SUBJECT: CHANGES TO TECHNICAL SPECIFICATIONS REGARDING LICENSEE'S ORGANIZATION (TAC NO. 64965)

RE: GRAND GULF NUCLEAR STATION, UNIT 1

AMENDMENT TO FACILITY OPERATING LICENSE

SAFETY EVALUATION BY THE OFFICE OF NUCLEAR REACTOR REGULATION

FIGURE 6.2.1-1 OFFSITE ORGANIZATION

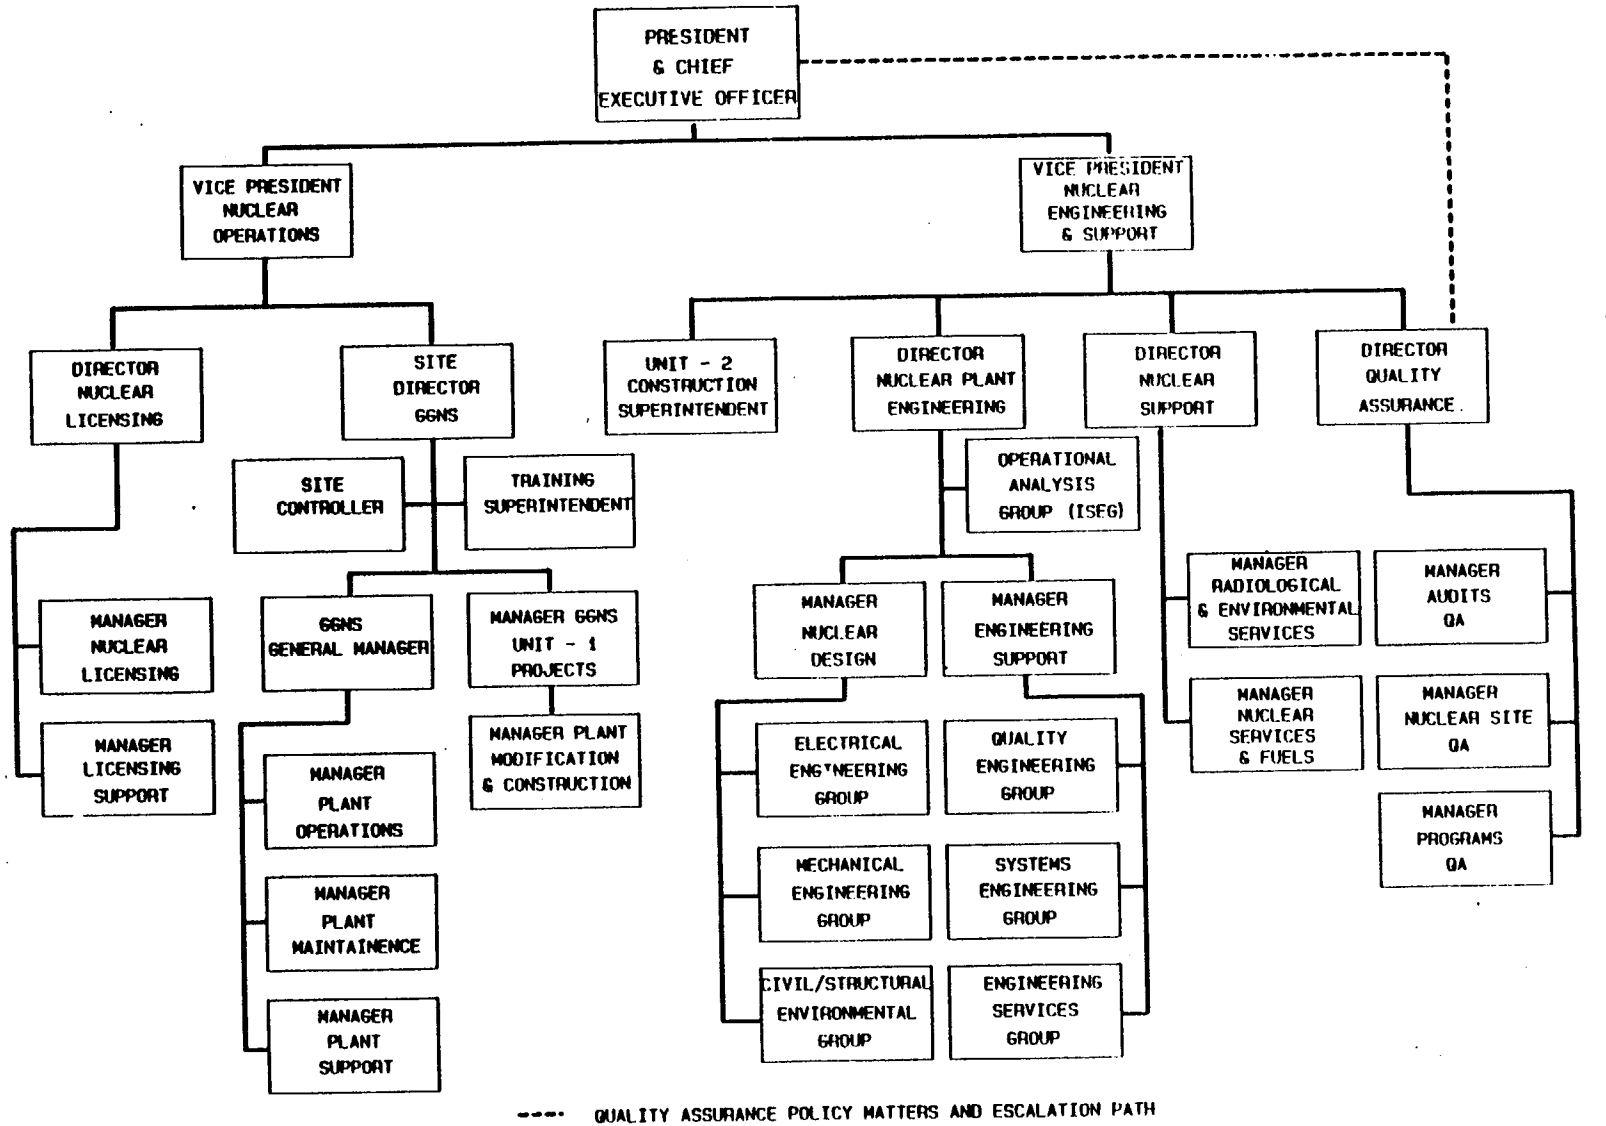
Offsite Organization - Figure 6.2.1-1

The organization under the Vice President Nuclear Operations has been revised to redefine the functions and change the title of Director Nuclear Licensing and Safety to Director Nuclear Licensing. The title for the Manager Nuclear Safety and Compliance, who reported to the Director Nuclear Safety and Licensing, has been changed to Manager Licensing Support and will report to the Director Nuclear Licensing. The reorganized department will retain all of the responsibilities of the former Nuclear Licensing and Safety Department with the exception of the emergency planning area which will be the responsibility of the Assistant to the Vice President, Nuclear Operations.

The organization under the Director Nuclear Plant Engineering, who reports to the Vice President Nuclear Engineering and Support, has been revised to establish the two new positions of Manager Nuclear Design and Manager Engineering Support. Reporting to the Manager Nuclear Design is the current Electrical Engineering Group, Mechanical Engineering Group, and the Civil/Structural Environmental Group. Reporting to the Manager Engineering Support is the current Quality Engineering Group, Systems Engineering Group, and the Engineering Services Group.

We find the changes to the Offsite Organization acceptable because they do not delete any of the technical support for Grand Gulf Unit No. 1 and the organization meets the acceptance criteria of Section 13.1 of NUREG-0800, the Standard Review Plan.

FIGURE 6.2.2-1 UNIT ORGANIZATION

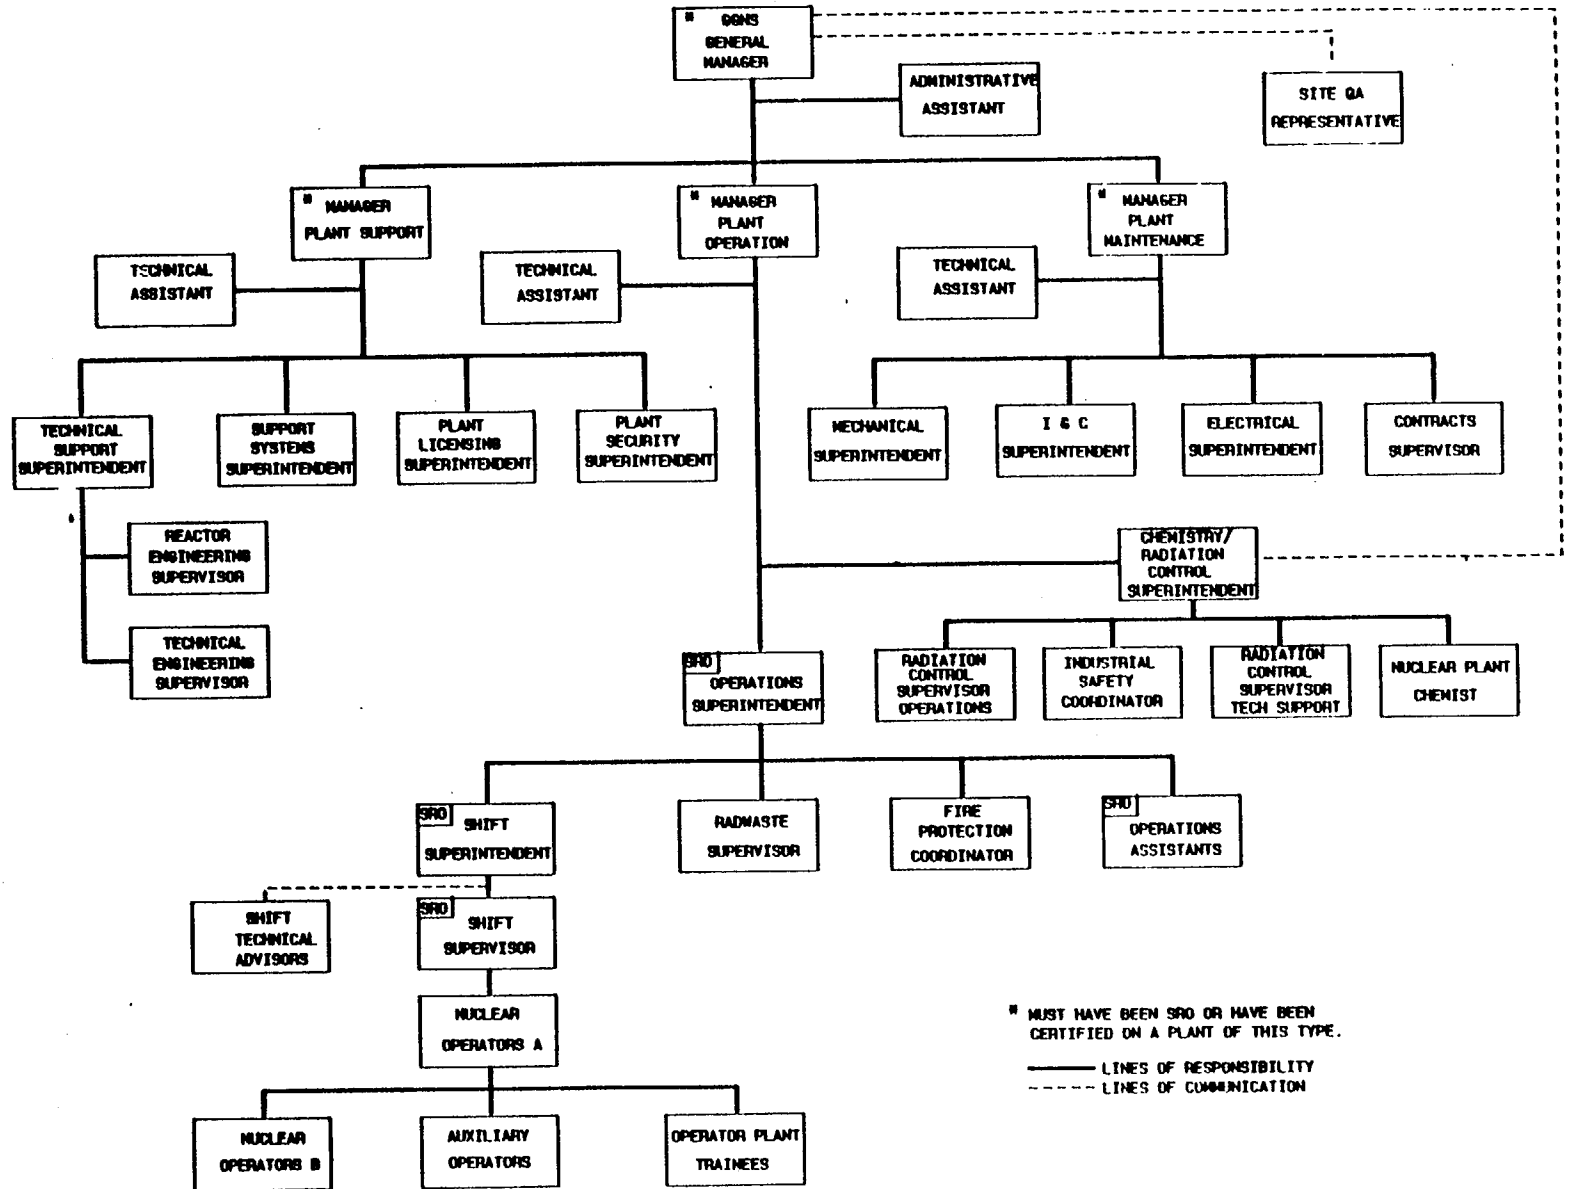
Unit Organization - Figure 6.2.2-1

The Technical Support Superintendent and his functions have been reassigned to the Manager, Plant Support from the Manager, Plant Operations. The Industrial Safety Coordinator and his functions have been reassigned to the Chemistry/Radiation Control Superintendent from the Manager, Plant Operations. Plant clerical functions have been consolidated under the retitled position of Office Services Supervisor (formerly Office Services Superintendent) who will report to the revised position of Support Systems Superintendent. The title of Supervisor of Plant Security has been changed to Superintendent of Plant Security without changing the job duties or responsibilities. The Training Superintendent and his responsibilities have been reassigned from the Unit Organization to report directly to the Site Director GGNS (Figure 6.2.1-1, Offsite Organization). The Plant Accountant and his functions have been reassigned from the Unit staff to report directly to the Site Director GGNS (Figure 6.2.1-1, Offsite Organization), under the new title of Site Controller. The Technical Assistant position reporting to the General Manager has been deleted and his responsibilities have been reassigned to the Manager, Plant Operations, Manager, Plant Maintenance and Manager, Plant Support.

We find the changes to the Unit Organization acceptable because they do not delete any functions necessary to support the operation of Grand Gulf Unit No. 1 and they meet the acceptance criteria of Section 13.1 of NUREG-0800, the Standard Review Plan.
